PROJECT NAME:
 4505 & 4605 SANDY PLAINS
 SUBDIVISION

PETITION NO: Z-28

ZONING COMMENTS:

STAFF RECOMMENDATIONS

DRAWING TITLE:
ZONING PLAN

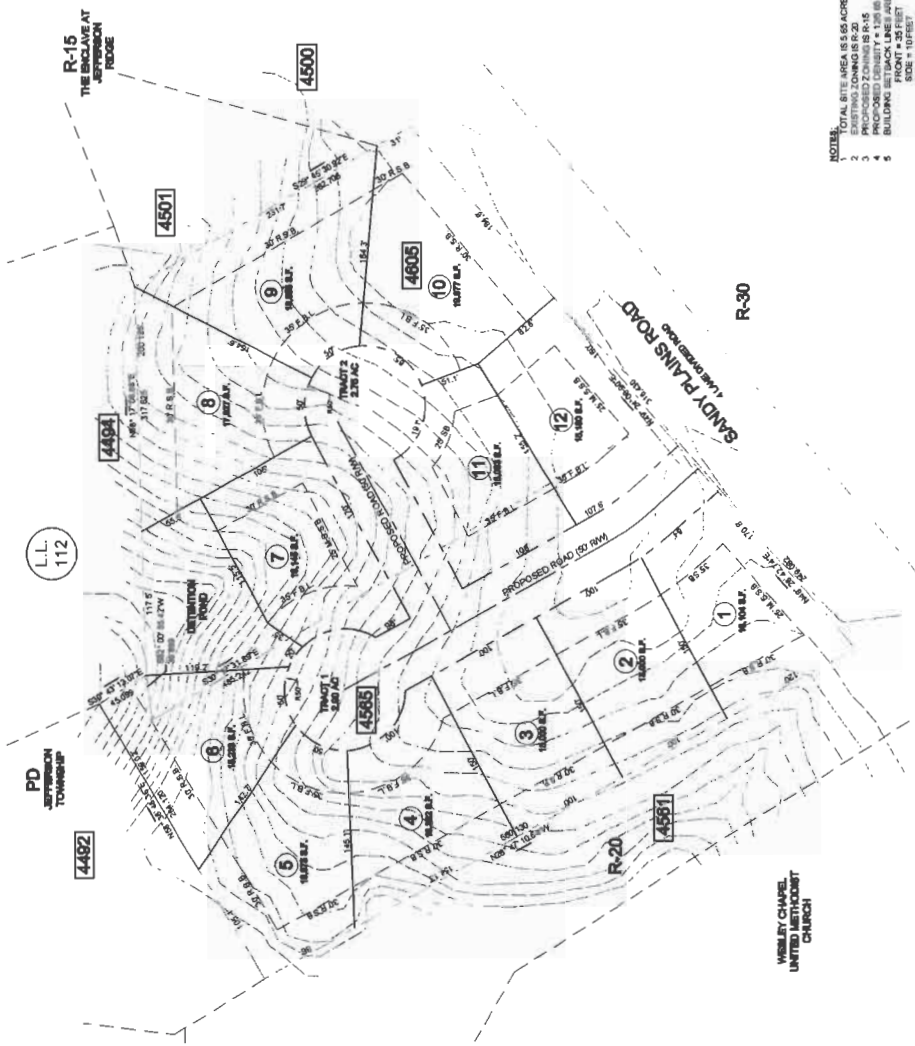
- No Stormwater controls shown _____
- Copy of survey is not current – Additional comments may be forthcoming when current site conditions are exposed.
- No site improvements showing on exhibit.

1. This parcel is located to the west of Sandy Plains Road. The majority of the site drains to the north directly into the Jefferson Township subdivision through two large lots. There is a natural drainage way leading to an existing 48-inch CMP private drive culvert, but no well-defined channel. A level spreader may be required for the proposed detention pond to lessen the impact of a concentrated discharge.
2. A drainage swale and easement will likely be required along the rear of lots 1-5 & possibly lot 8 to limit offsite runoff bypass.
3. A pre- and post-development sediment survey will be required for the downstream private pond.

Sandy Plains Road is classified as an arterial and according to the available information the existing right-of-way does not meet the minimum requirements for this classification.

- A. It is Staff's opinion that the applicant's rezoning proposal will not permit a use that is suitable in view of the use and development of adjacent and nearby properties. While there are R-15 properties in the area, applicant's proposed density is higher than those R-15 and R-20 properties developed in the past few years.

- B. It is Staff's opinion that the applicant's rezoning proposal will have an adverse affect on the usability of adjacent or nearby property. While there is an R-15 subdivision to the northeast of the subject property at 1.96 units per acre, applicant's proposed density slightly higher at 2.12 units per acre. The proposed density is also higher than a recent nearby R-20 development that has a density of 1.15 units per acre.

- D. It is Staff's opinion that the applicant's rezoning proposal is not in conformity with the policy and intent of the *Cobb County Comprehensive Plan*, which delineates this property to be within the Very Low Density Residential land use category having densities ranging from 0-2 units per acre. Applicant's proposed density is 2.12 units per acre. Other zonings and densities in the area include two portions of Jefferson Township (Phases 1 and 10) having densities of 0.47 units per acre and 0.59 units per acre respectively; Mountain Creek Estates, nearby on Mountain Road, zoned R-20 (Z-11 of 2011), with a density of 1.15 units per acre; The Enclave at Jefferson Ridge, east of subject property, zoned R-15 (Z-42 of 2003), having a density of 1.96 units per acre; and Jefferson Park, across from The Enclave at Jefferson Ridge on Sandy Plains Road, zoned R-15 having a density of 2.06 units per acre. Applying the density average from the Zoning Ordinance for the R-20 category, nine units could be developed yielding an approximate density of 1.59 units per acre.

Recommend applicant consider entering into a development agreement pursuant of O.C.G.A. 36-71-13 for dedication of the following system improvements to mitigate traffic concerns: a) donation of right-of-way on the north side of Sandy Plains Road, a minimum of 50' from the roadway centerline.

Recommend curb and gutter along both sides and sidewalk along one side of proposed development roadway.

Recommend a deceleration lane on Sandy Plains Road for the entrance.

Based on the above analysis, Staff recommends DENIAL.
